Submissions and Preferred Infrastructure Report

Newcastle Inner City Bypass
Rankin Park to Jesmond

Newcastle Inner City Bypass – Rankin Park to Jesmond Submissions and preferred infrastructure report

Roads and Maritime, as the proponent of the project, has prepared this submissions and preferred infrastructure report to respond to issues raised in submissions and describe and assess design refinements made since the exhibition of the EIS.

Figure 5-11a
Drainage infrastructure

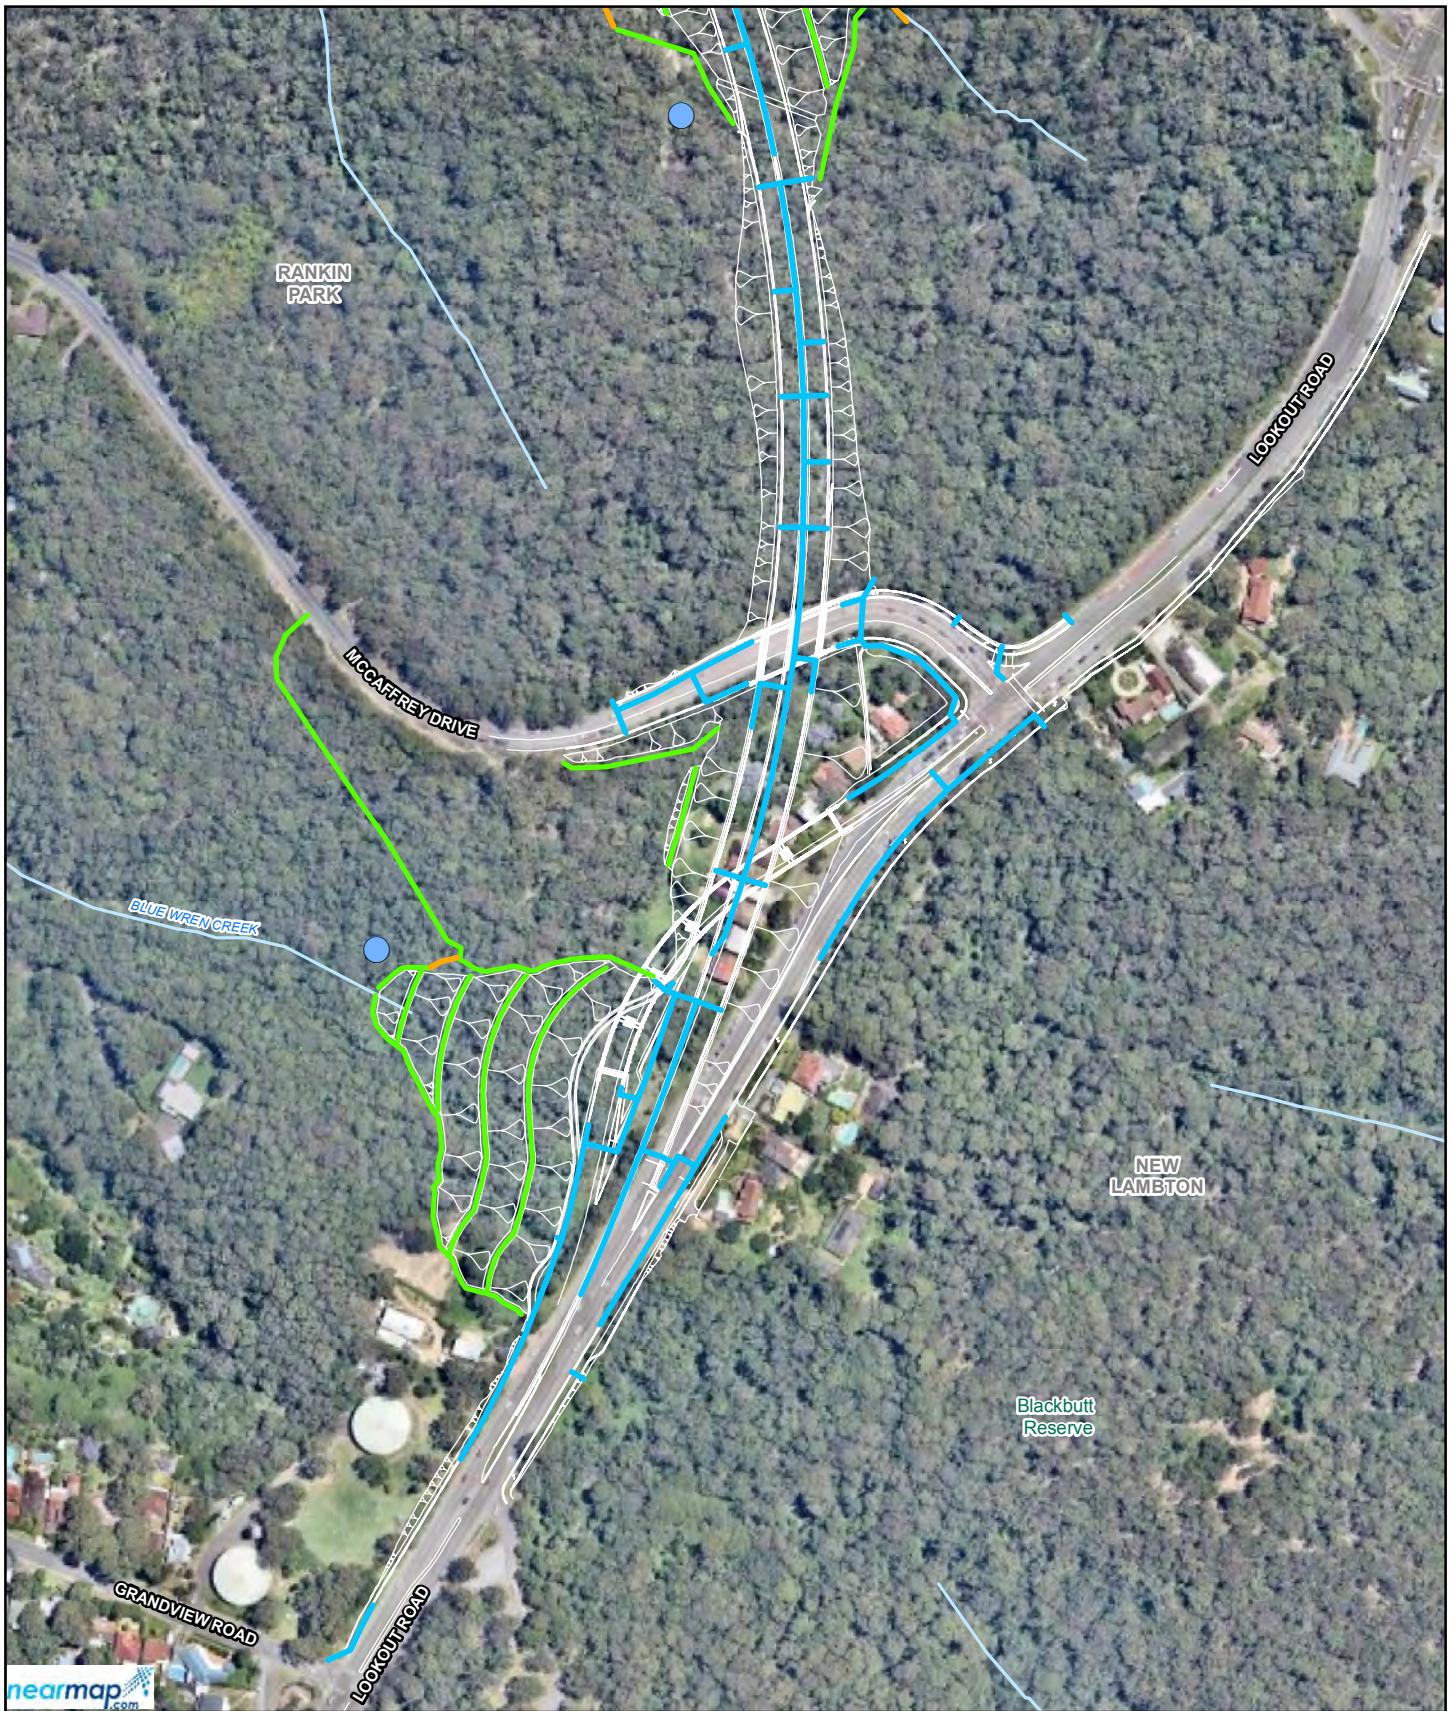
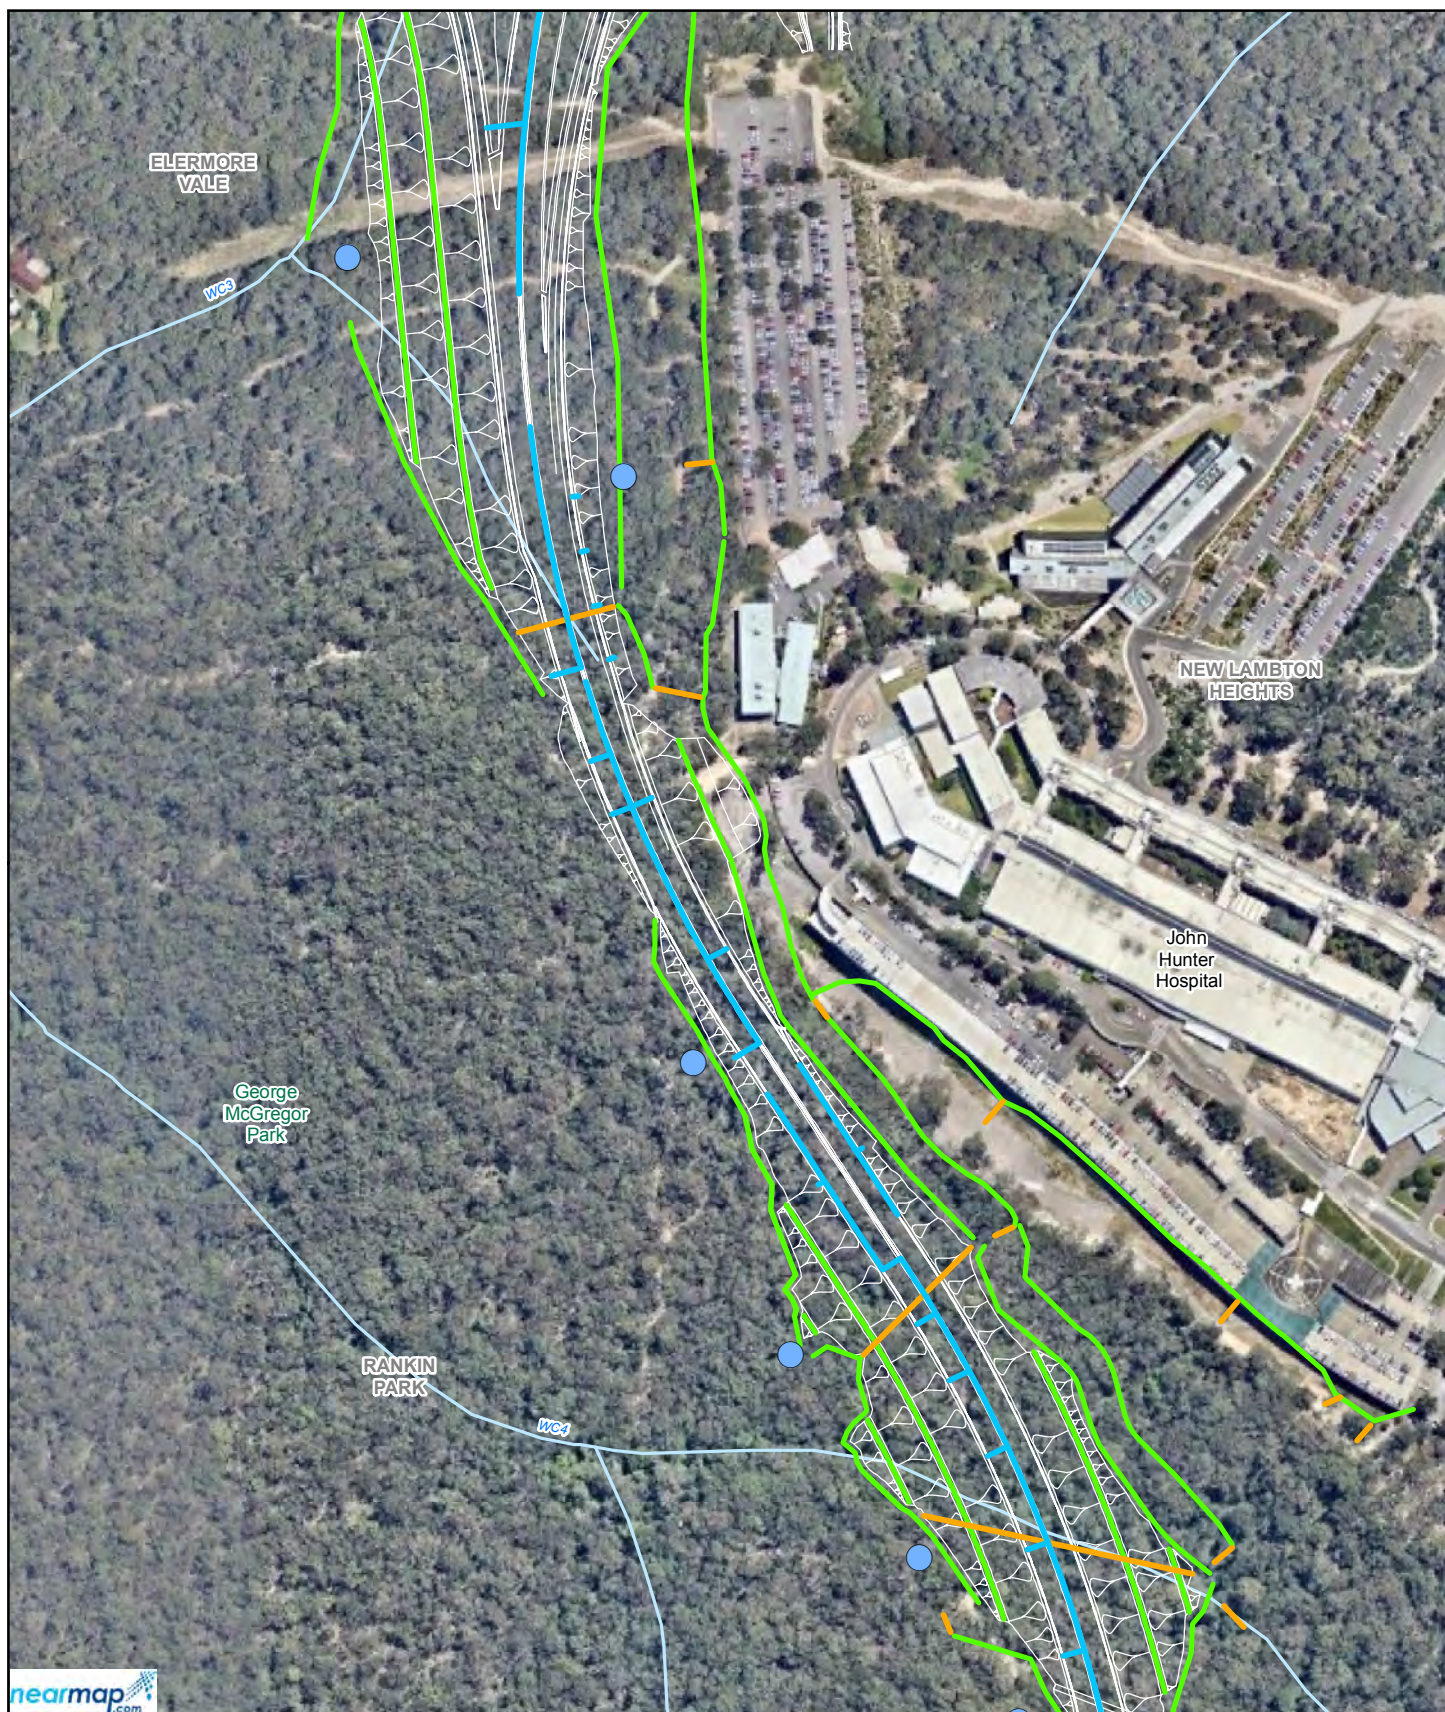
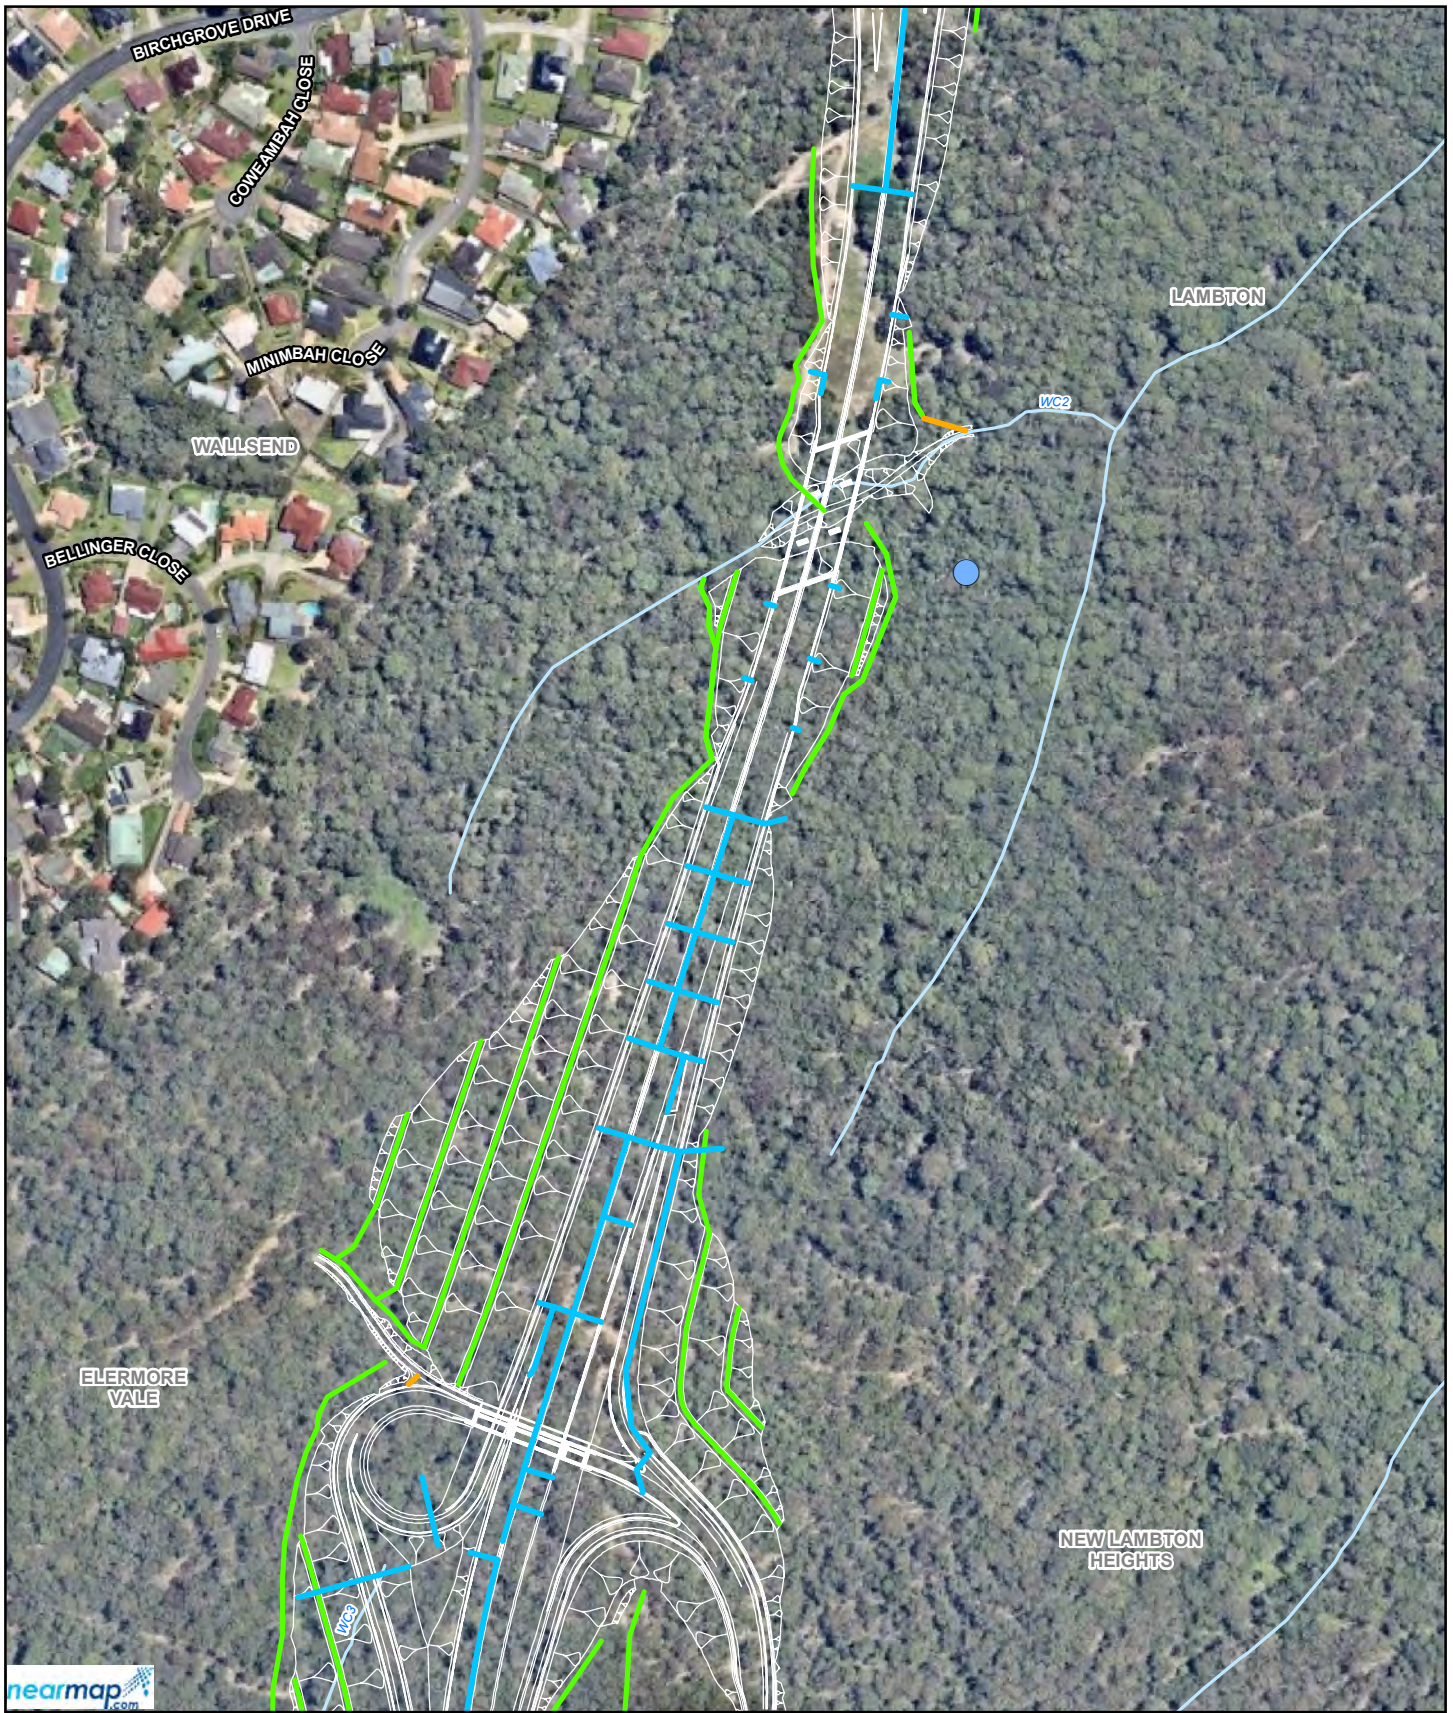
Due to the design refinements discussed in this report the proposed drainage infrastructure has now been refined as shown in Figure 5-11. The refined design is consistent with that described in the EIS and includes minor changes to cross drains, pavement drains and longitudinal catch drains to reflect other design refinements including the:

Due to the design refinements discussed in this report the proposed flood mitigation work has now been refined as shown in Figure 5-11 and consists of:
